TO: James L. App, City Manager
FROM: Ronald Whisenand, Community Development Director
SUBJECT: Chandler Ranch Area Specific Plan Up-Date and Options
DATE: November 27, 2007

CHANDLER RANCH SPECIFIC PLAN

29 OCTOBER 2007

Prepared by:
Moule & Polyzoides Architects and Urbanists

Southern portion of Chandler Ranch Specific Plan area as abuts Olsen Ranch Beechwood Specific Plan area.

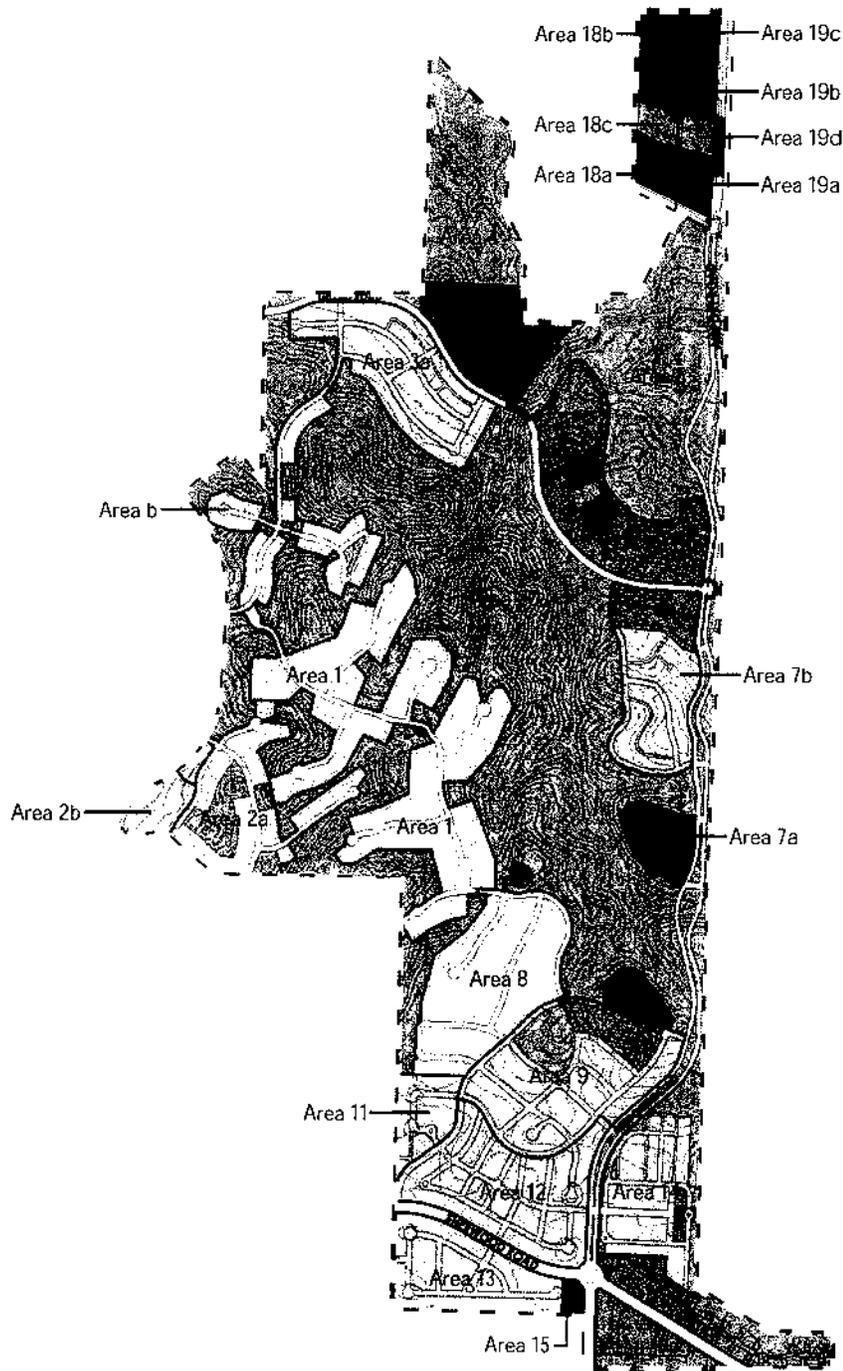
Perhaps the greatest improvement to the master plan to date has been the unification of the plan for Areas 8, 9, 11, 12 and 14. In the July 30 meeting the possibility of reorienting lots around the edges of Areas 9 and 12 so that they front the perimeter streets rather than backing to them was discussed, as was the possibility of more unified planning as regards areas 13, 15, 16 and 17.

As the drawing on the facing page demonstrates, this South Neighborhood directly abuts the north neighborhood of the Olsen Ranch-Beechwood Specific Plan, such that the neighborhood-serving commercial center on the south side of Sherwood Road is facing the soundwall of the six-pack product on the north side of Sherwood. This would be a truly terrible outcome of so many years of planning effort.

Accordingly we provide some comments regarding these areas as a group. We still have significant concerns about the details of the layouts for these areas, but the clear conceptual intention is that they be joined together into a single neighborhood of interconnecting streets and reasonably scaled blocks. Specific concerns about this layout include:

- b. The block sizes in Area 12 are very small and it appears that some of the blocks must be only one lot deep. In the July 30 meeting the possibility that some of the streets are actually alleys was discussed. This area should be redrawn, including some illustrative lotting, so that the difference between streets and alleys is clear, and hence the fronts and backs of lots are clear. In blocks where larger lots are planned, alleys are completely optional, but if lots less than 60 feet wide are contemplated, provision should be made for alleys. Also the lots abutting Sherwood Road and Airport Road should have alleys, so that driveways do not connect to Airport Road or Sherwood Road. Elsewhere, the decision to include an alley or not can certainly be made when the tentative map is prepared and the lot sizes and building types are known.

rural avenues it is completely inappropriate. And to have this condition across the street from the fronts of residences and/or small commercial establishments in Area 12 and the Olsen Neighborhood would be doubly damaging. The layouts of these areas need to be redesigned to correct this.

Chandler Ranch Specific Plan Areas 1, 2A, 2B, 3A, and 3B.

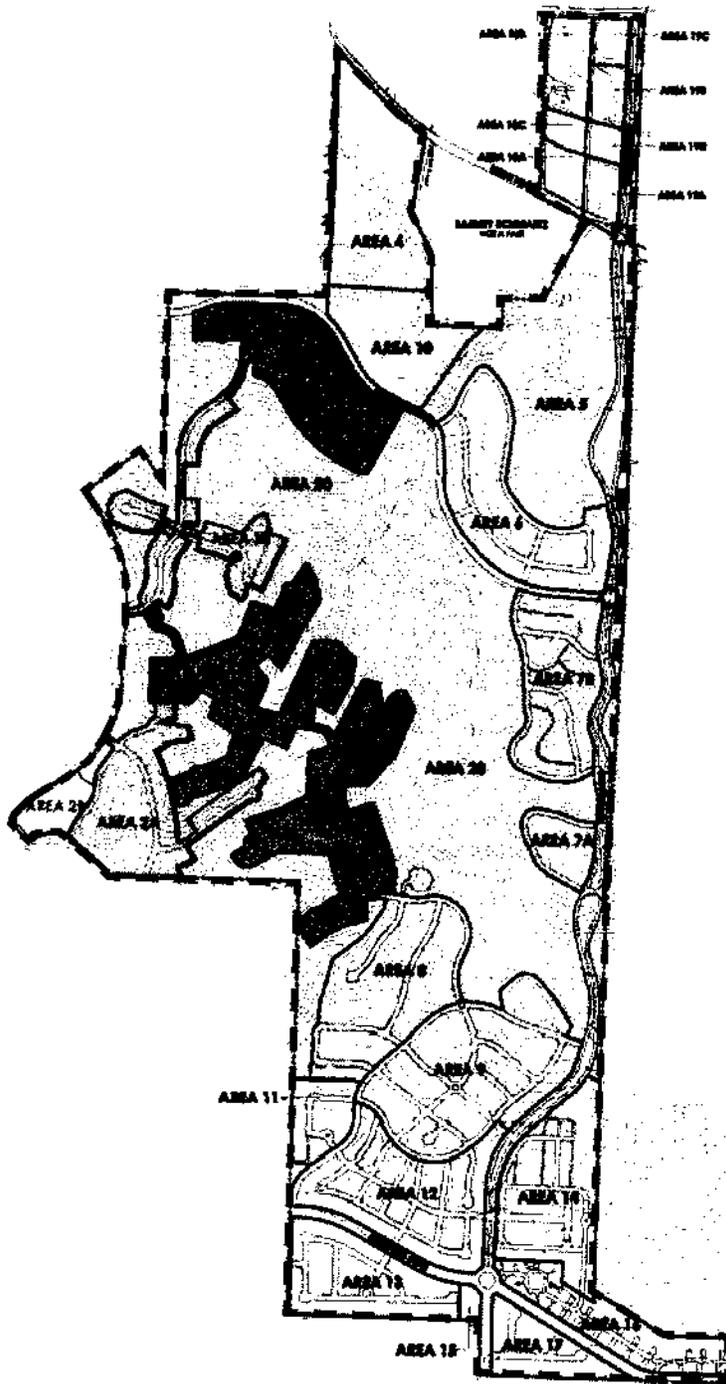
The design intent for this area is to preserve the existing topography and vegetation, and gently set houses down among the oak trees. This seems like a strong concept, and carefully implemented this would provide a unique and rural living environment. The master plan as drawn seems to be conceptually fine.

- a. Roads are narrow and have naturalistic verges (shoulders) with drainage in swales that are landscaped with drought-tolerant native plants, and local river rock where stabilization is needed.
- b. Fences and landscaping are open and of rural character.

The layout is conceptually correct as shown. Note that the area in the northwest corner of 3A is a naturalistic water quality basin and not lots that back up to Gilead, and that the alley shown south of Gilead allows for homes fronting Gilead. Gilead must have on-street parking for visitors to those homes.

It is recommended that the blocks in the middle of 3A also have alleys, unless the lots are at least 60 feet wide. It is understood that the perimeter lots on the south and east edges of area 3A are very minimally graded, with houses that conform themselves to the uphill lot condition and back yards that seamlessly connect to the adjoining natural open space. Property line fences should conform to the T2 standards along those edges.

Developed standards should be T3 (Suburban)

Chandler Ranch Specific Plan Areas 4, 5, 6, 7A, and 7B.

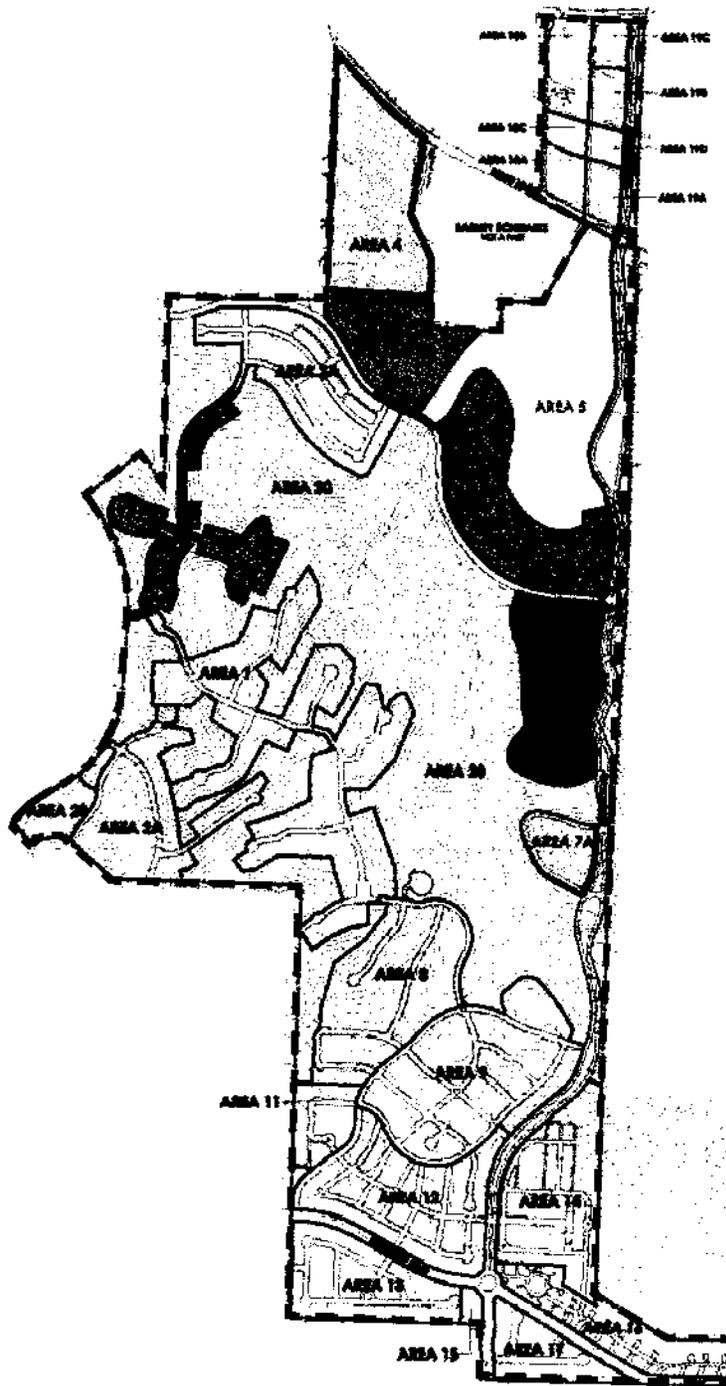
Area 4 is conceived as a large park or public open space, although it has potential to accommodate a large-scale private recreational facility. Regardless of the final use, an illustrative landscape master plan should be prepared and the character of landscape and other improvements should be per the T2 (Rural) standards.

Area 7A is currently a single generally round block. The current housing density diagram indicates that higher densities are planned for that area. While it is possible to design buildings containing denser housing that would look appropriate sitting in a little block that is surrounded by natural open space and vineyards, the chances of a merchant builder doing so are negligible. We strongly recommend that this area be planned for single-family detached homes that substantially preserve the existing contours of

The layout shown for 7B is quite good, providing lots that front Gilead and Airport on the north and east edges, as well as the roads adjoining the open space along the west and south edges. The alleys that have been added provide vehicular access to the lots, providing a great deal of flexibility in lot widths, and allowing the front yards to be beautifully landscaped and free of automobile parking.

The internal street in the southerly portion of this area comes very close to Airport Road causing some undesirable results. The lots in the southwest portion of the area are very deep, whereas the lots in the southeast portion, facing Airport Road are very shallow, and either back up to Airport Road or to the internal street, neither of which is a good option. If that internal street were shifted to the west, there could be an entire block to the east of it, such that lots fronting Airport Road and fronting the internal street would be possible. That block should contain an alley to avoid driveways onto Airport Road.

All of the neighborhood edge streets must have curbside parking for visitors. On Airport Road, and on the road along the west and south edges, parking could be accommodated on a wide shoulder composed of pervious pavement (such as pervious concrete, pervious pavers, or other permeable surfaces that are approved by the Planning Director). On Airport Road, parking could also be accommodated along a frontage lane that would also facilitate access to homes facing Airport Road. This second alternative is probably the better solution for carrying relatively heavy traffic loads and at the same time allowing buildings and street parking to front on the narrower, quieter, and separate frontage lanes. Both configurations could be lined with informally planted oak trees that emphasize the rural character of the streets.

T3 (Suburban) standards should apply.

Chandler Ranch Specific Plan Areas 8, 9, 10, 11, 12, 13, and 14.

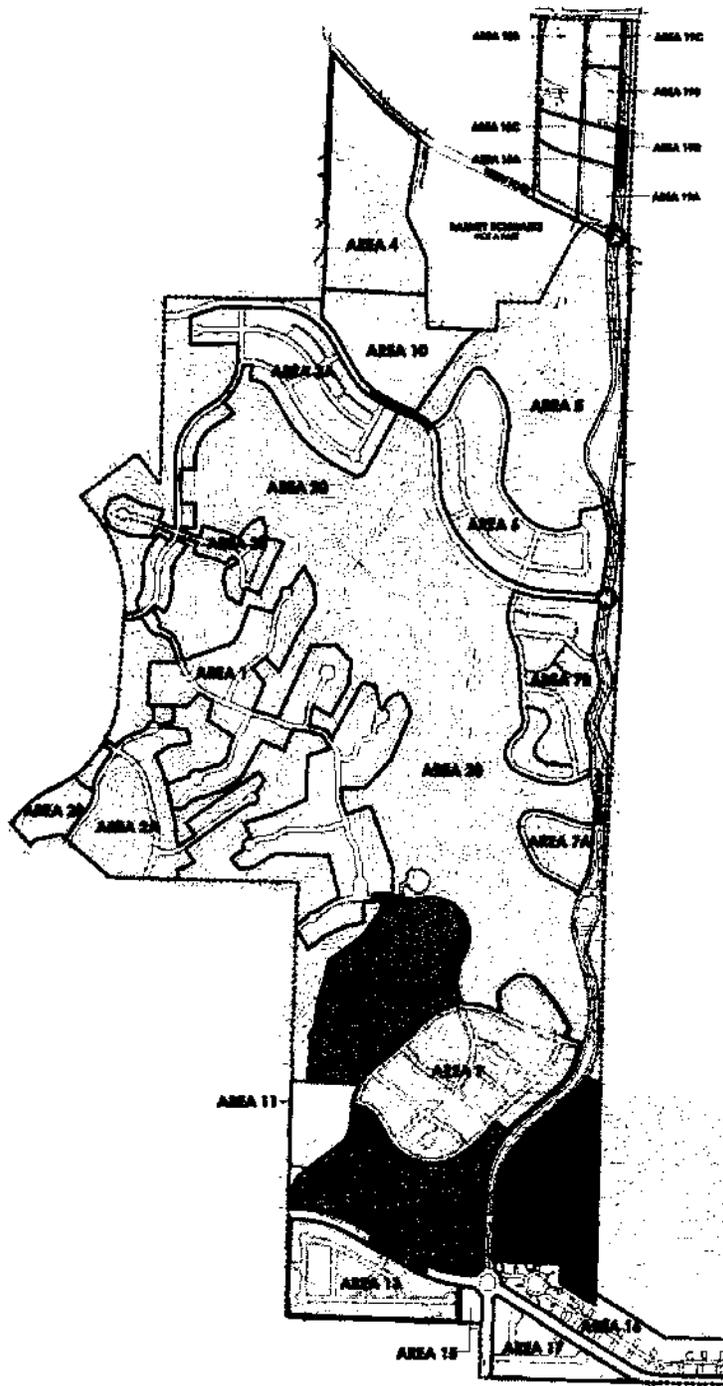
If Area 8 is to be exclusively large-lot single family houses, the layout as shown would work. If a range of lot sizes, including some less than 60 feet in width, are anticipated, then the blocks may need to be reduced in size and/or alleys may need to be added.

If Area 9 is to be exclusively large-lot single family houses, the layout as shown would work. If a range of lot sizes, including some less than 60 feet in width, are anticipated, then the blocks may need to be reduced in size and/or alleys may need to be added.

Area 11 cannot be planned independently of Areas 8 and 9. See comments for those areas, above.

This area appears to heading toward a neighborhood center character, and we recommend further clarifying that intention. We also recommend that buildings front Sherwood, with and/or without a frontage road, and that serious consideration be given to locating non-residential uses along the Sherwood frontage.

T4 (General Urban) standards should apply.

Chandler Ranch Specific Plan Areas 15, 16, and 17.

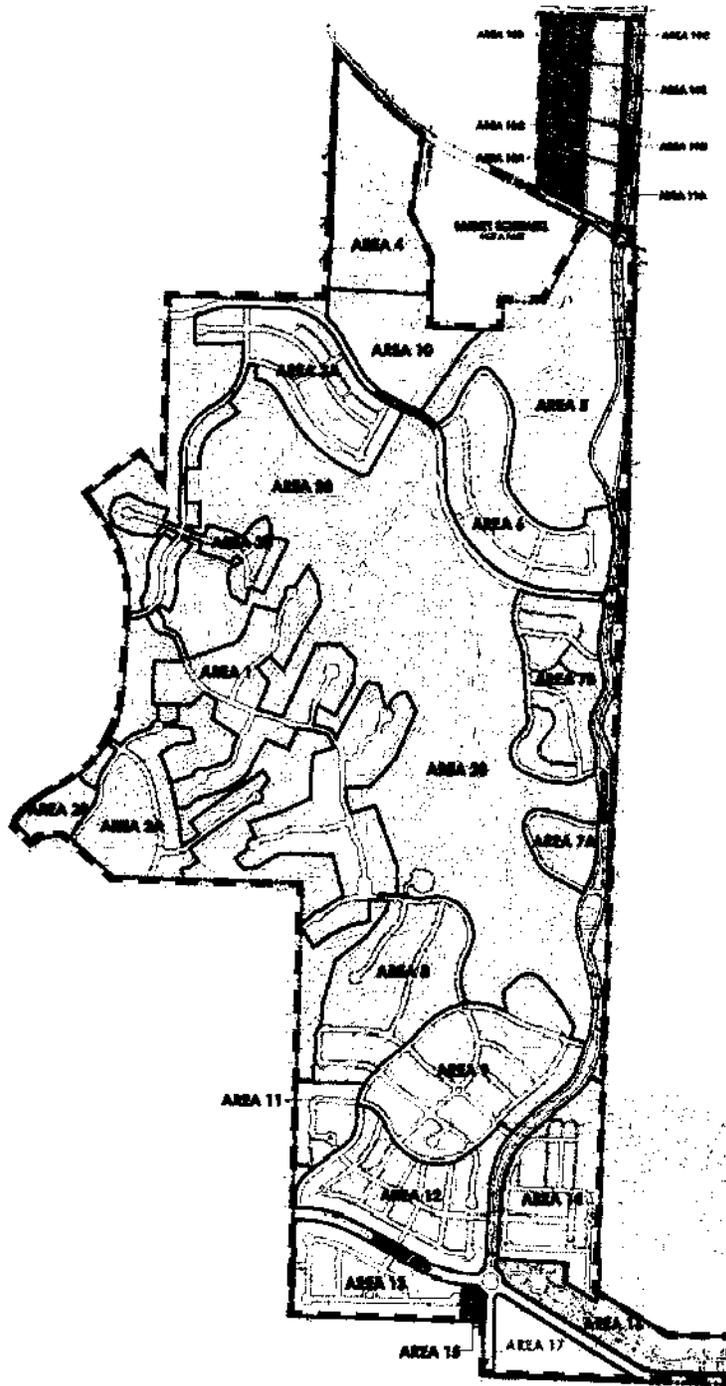
This area cannot be planned separately from Area 13. See comments for that area above.

As noted in the general comments for the south neighborhood, the layout for Area 16 is clearly inappropriate. The planning for this area needs to be unified with Area 14 to the north, and with the Olsen Neighborhood Center to the south. Buildings should front Sherwood Road, not back to it.

This area needs to be redesigned, similarly to Area 13. Its shape is challenging but provides a very high ratio of frontage to area, which would add value to a commercial use whereas it subtracts value from a single family residential use.

Areas 18 and 19 need to be planned in a unified way, regardless of whether they are developed at separate times by separate entities, or all at once. Accordingly, we provide one set of comments for the two areas.

The land to the north of the creek and adjacent to Highway 46 (Areas 18B, 19B and 19C) appears suitable for a highway oriented commercial use. Buildings in this area should face Highway 46 and/or Airport Road, with a frontage road behind a parkway with strong, rural landscaping and tree plantings. Access to Areas 18 and 19 should be linked by this frontage road, with a consistent design. One end of that frontage road should connect to Airport Road an appropriate distance from Highway 46, and the other end should end at the western edge of Area 18 with the possibility of extending it westward should topography and development of adjacent property permit. Rather than a dead end or cul-de-sac, it is recommended that a loop be completed via driveways or alleys that provide access around and behind buildings that front Highway 46 and the frontage road. If the

properties are developed separately, reciprocal access and parking easements should be recorded to assure a unified operation as well as design.

Parking lots in front of buildings, if provided, should be no more than one aisle in depth, and designed and landscaped as parking along a frontage road rather than as a typical shopping center parking lot. Additional parking should be behind the buildings, or in moderately sized "parking courts" between buildings. A shared parking area between Areas 18 and 19 might be provided with a shared drive aisle on the boundary between the areas.

The land south of the creek and adjacent to Union Road (Areas 18A, 18C, 19A and 19D) are located within the boundaries of the City's Airport Land Use Plan and is thus more suitable for neighborhood-serving commercial use. Commercial buildings should front Airport Road and/or Union Road, with or without a frontage road. If parking is provided in front of these buildings it should either be on-street parking or parking detailed as a frontage road, as noted above.

In the case of both of these areas, the design of the creek edges will be important. A variety of conditions may be appropriate along the creek depending on the selected uses, including a restaurant with a deck or garden along the creek, or in some cases parking areas. If parking areas are located along the creek, a prototype for their design would be Olohan Alley and Kiwanis Park in Arroyo Grande – pervious pavement and carefully designed bio-swales and infiltration basins should be provided to control the quality and quantity of stormwater delivered to the creek.
